# and Management Parameters for 10 Mb/s Operation and Associated Power Delivery over a Single Balance

Cl 45 SC 45.2.7.25.1 P 58 L 35 # i-230

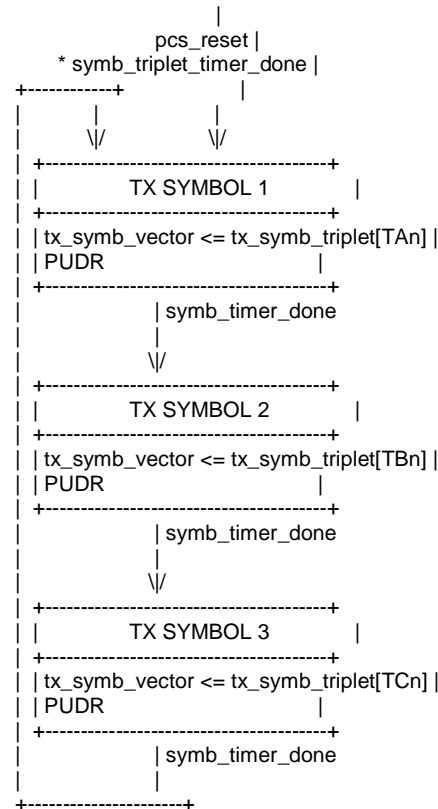
Is it correct that 'The PCS Transmit function shall conform to the PCS Transmit state diagram in Figure 146-5 ...' and that 'In each symbol period, PCS Transmit generates a symbol An provided to the PMA ...'? The PCS Transmit state diagram in Figure 146-5 changes state based on STD being true, with STD being an alias for symb\_triplet\_timer\_done, and the output of the PCS Transmit state diagram is tx\_symb\_triplet which is defined in subclause 146.3.3.1.1 'Variables' as 'A triplet of ternary symbols generated by the PCS Transmit function after 4B3T encoding.'

I think the problem is that there is another function within the PCS Transmit function that is missing from the PCS Transmit state diagram in Figure 146-5, the 'multiplexor' shown in Figure 146-6 'PCS transmit symbol generation'. This 'multiplexor' function operates at the symbol clock rate and serialises the tx\_symb\_triplet code-groups output by the PCS Transmit state diagram into individual symbols.

This may also explain when subclause 146.3.3.1.3 'Timers' defines the symb\_timer that is not used in the PCS Transmit state diagram in Figure 146-5.

[4] Add a new subclause 146.3.3.2.2 titled 'Timers'. Move the symb\_timer definition from subclause 146.3.3.1.3 Timers to this new subclause.

[6] Insert a new Figure 145-6 shown below (view using a non-proportional font such as courier), renumbering the following figures as required.

[7] Add text to subclause 146.3.3 'PCS Transmit' that reads 'The PCS Transmit function shall conform to the PCS Transmit state diagram in in Figure 146-5 and the PCS Transmit multiplexor state diagram in 146-6, and their associated state variables, functions, timers, and messages.'
